Bulletin No.:	9573L30-01
Corp. Ref. No.:	57-71-09
Date:	April, 1995

SUBJECT: TORQUE CONVERTER CLUTCH (TCC) CHUGGLE/HUNTING CONDITION

MODELS: 1989-1995 GEO TRACKER, CAMI VITARA, SUZUKI SIDEKICK WITH HYDRA-MATIC 3L30 AUTOMATIC TRANSMISSION

Figure 1

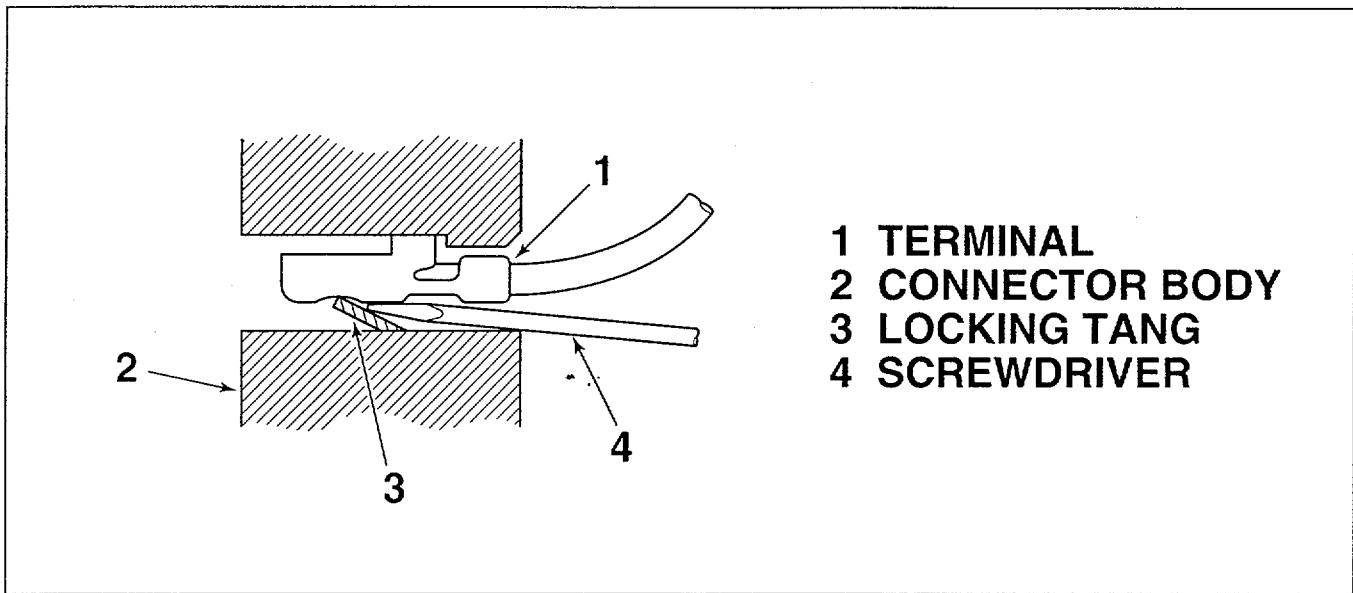
3. Disconnect the white wire from the green connector. Remove the terminal **carefully** with a narrow screwdriver as indicated. (Figure 1)
4. Connect the white wire to the Time Delay Module and wrap with electrical tape. Install the red wire from the Time Delay Module into the open terminal of the green TCC relay connector. (Figure 4)
5. Reconnect the green connector to the TCC relay and install the TCC relay onto the relay center. (Figure 4)
6. Clip the Time Delay Module onto the A/C fan relay. (Figure 3)

Figure 2

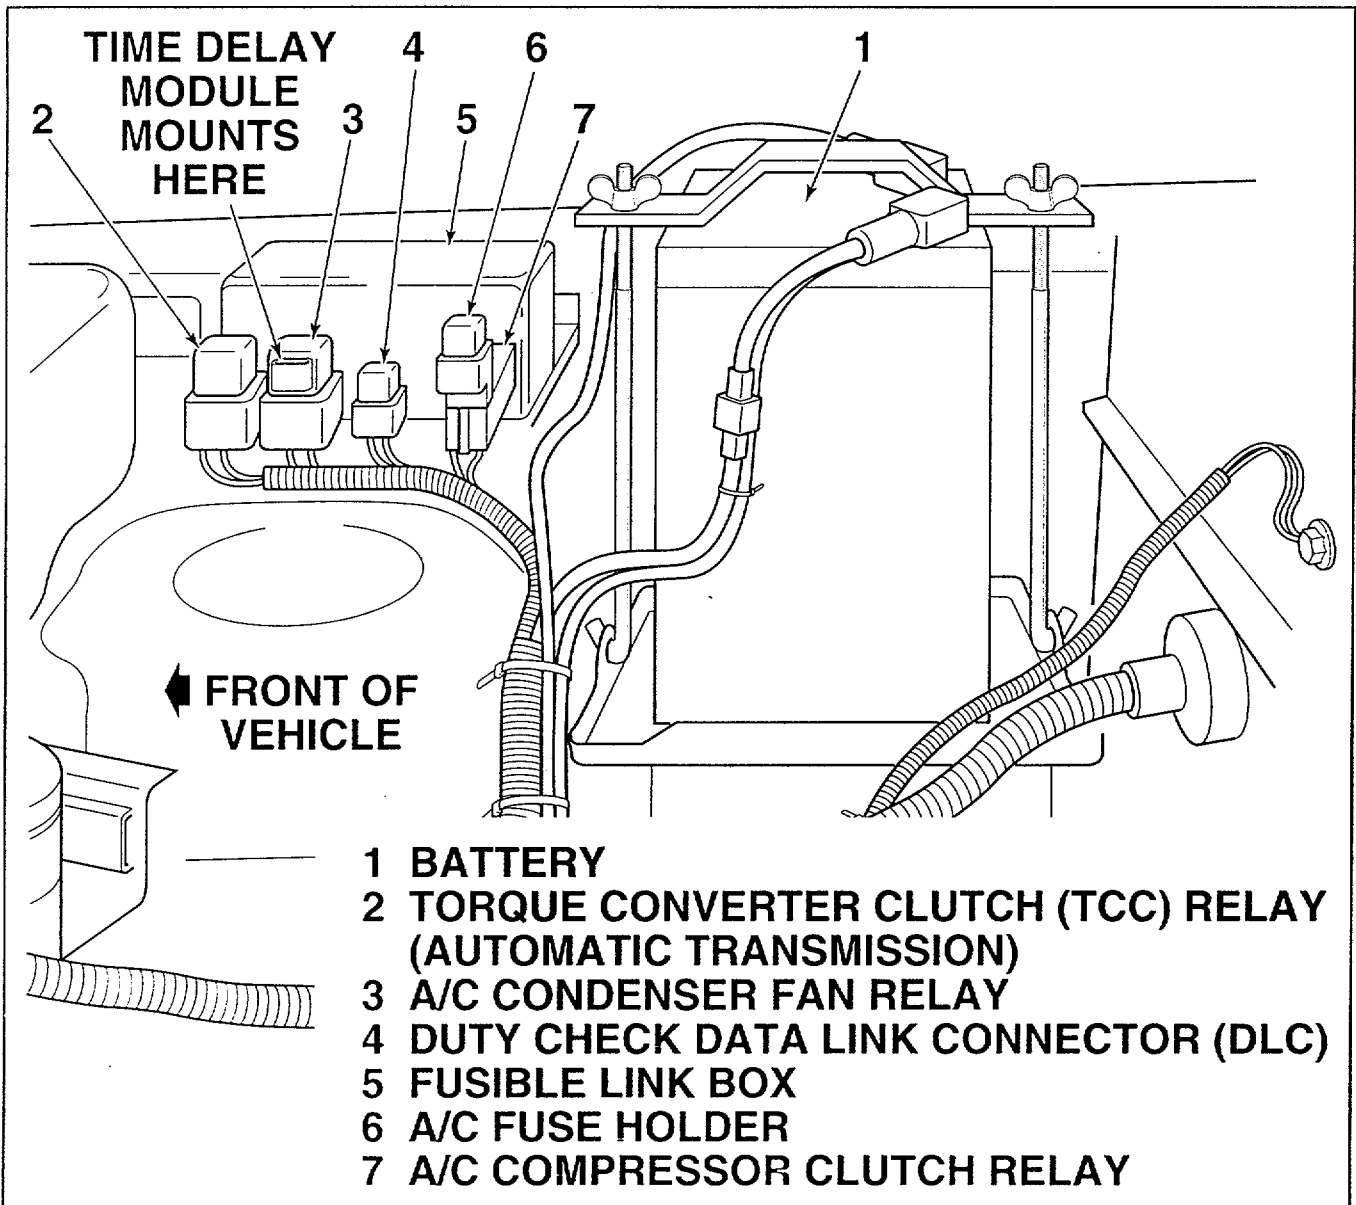
1. Disconnect the battery. (Figure 2)
2. Disconnect the green connector from the TCC relay. (Figure 2)

Figure 1

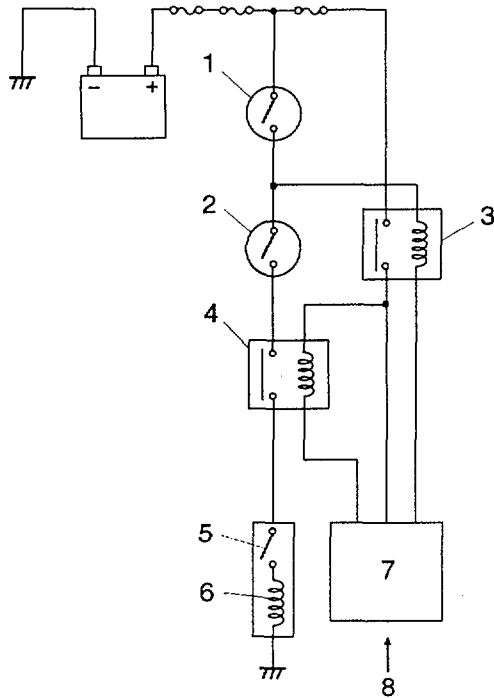
This bulletin is to inform you of a modification in the ECM which is effective in 1995 model year vehicles matching or exceeding the VIN numbers listed below. The Torque Converter Clutch (TCC) Relay Control System in 1995 and later 2-door Sidekick Automatic Transmissions has been modified to operate through ECM control, replacing the Pressure Switch in the valve body. Because of this modification, the ECM and the diagnostic procedures related to the TCC Relay Control System have been changed. If the vehicle matches or exceeds the starting VIN numbers listed below, please use the diagnostic procedures as listed in this bulletin.

This system controls the TCC relay, one of the components that controls the torque converter clutch. A circuit diagram of this system is shown in Figure 1.

- Engine is running
- Engine coolant temperature is above 60°C (140°F)
- Throttle valve opening is between 6.4° and 62.5
- Vehicle speed is higher than
 - 40 mph (64 km/h, 8-valve engine) or
 - 47 mph (75 km/h, 16-valve engine, late type ECM only).

EARLY

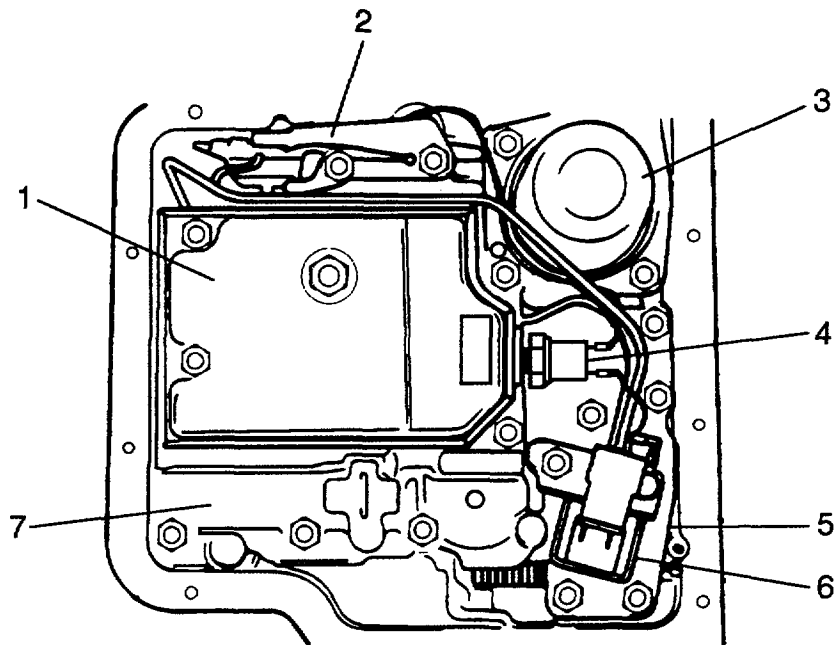
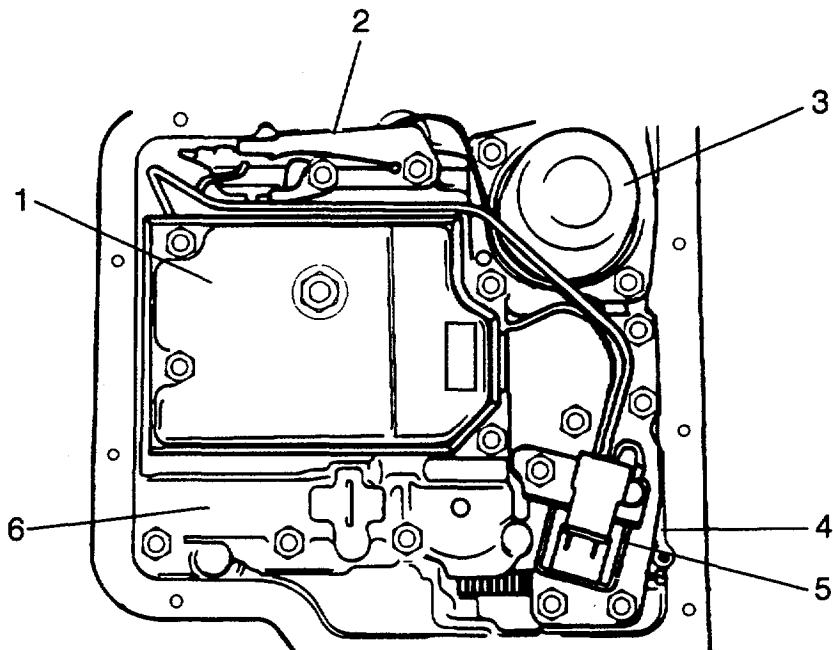
CONDITION: Change in Automatic Transmission; elimination of A/T oil pressure switch.

This bulletin is to inform you of the elimination of the Torque Converter Clutch (TCC) Oil Pressure Switch which has been carried out since May 1995 production for Canadian models and August 1995 production for Japan models. Due to this modification, the diagnostic procedures for the TCC system in the service manual have been changed. Please refer to Technical Service Bulletin #TS 3-25 to diagnose this system.

Figure 1

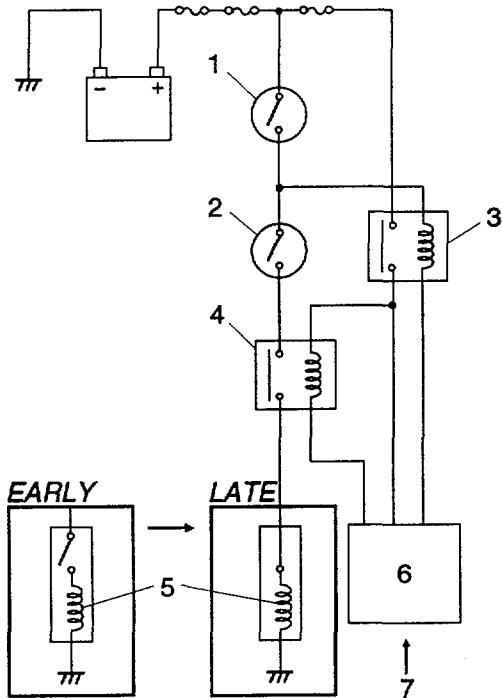
This system controls the TCC relay, one of the components that controls the torque converter clutch. A circuit diagram of this system is shown in Figure 1.

For diagnostic procedure, please refer to Technical Service Bulletin #TS 3-25. Also note that the continuity check between ① pin of TCC relay coupler and ground is not needed due to the elimination of the A/T oil pressure switch.

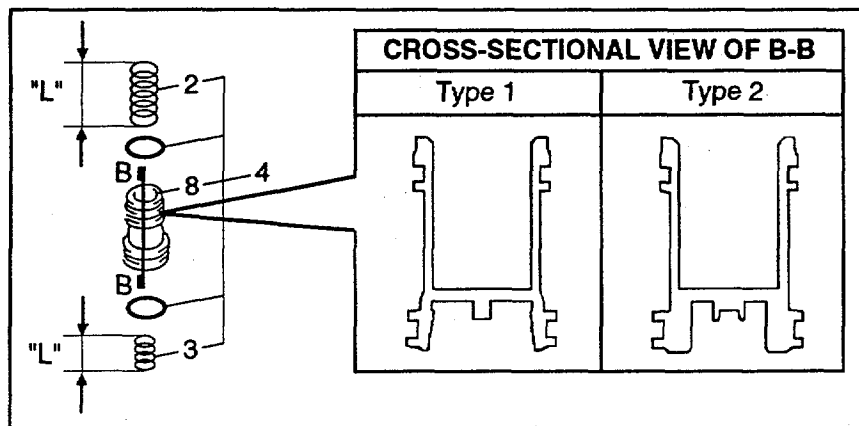
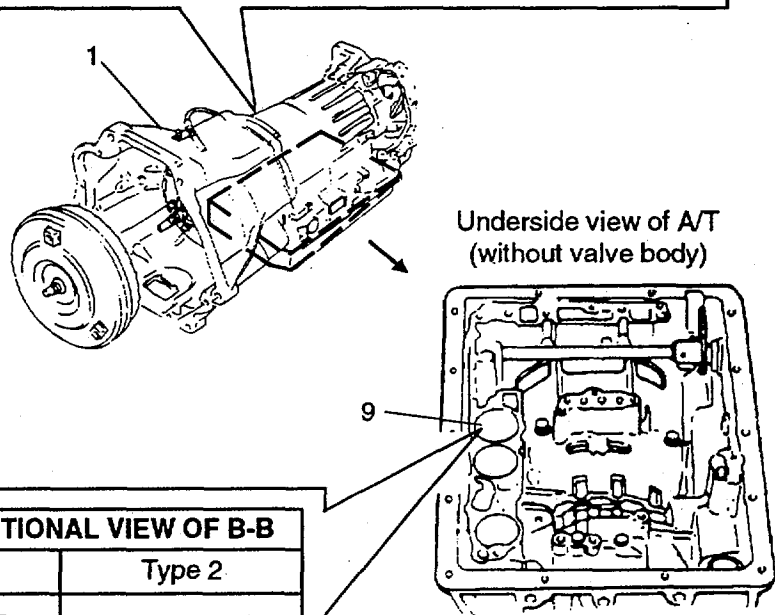
This bulletin is to inform you of the modification of the inner parts for the 4-Speed Automatic Transmission which has been carried out since January 1997 production. The modifications listed in this bulletin were introduced to reduce gear shift shock when shifting from Neutral to Drive, Neutral to Reverse, and First to Second gears. When rebuilding the transmission, please use the parts as listed in this bulletin.

Three (3) types of A/T assemblies were manufactured with different pistons and springs, noted in the table below as ①, ②, and ③. These assemblies are identifiable by the following criteria:

REF. NO.	PART NAME	SPRING LENGTH ("L"), SPRING ID COLOR, AND PISTON TYPE							
		①		②		EARLY		LATE	
		①	②	③	①	③	①	②	
2	Second brake accumulator No. 2 spring	2.172 in. (55.18 mm) (Light Green)	→	2.211 in. (56.16 mm) (Purple) *	→	2.220 in. (56.40 mm) (Green)	→	2.172 in. (55.18 mm) (Light Green)	
3	Second brake accumulator No. 1 spring	1.383 in. (35.13 mm) (Red)	→	0.728 in. (18.50 mm) (Purple) *	→	0.689 in. (17.50 mm) (Red)	→	1.383 in. (35.13 mm) (Red)	
8	Second brake accumulator piston	Type 2	→	Type 1 *	→	Type 1 *	→	Type 2	
AT Serial Number		To 95DQ61560 or 95HQ61360		From 95DQ61561 to 96MQ65010 or from 95HQ61361 to 96MQ65405			From 96MQ65011 or 96MQ65406
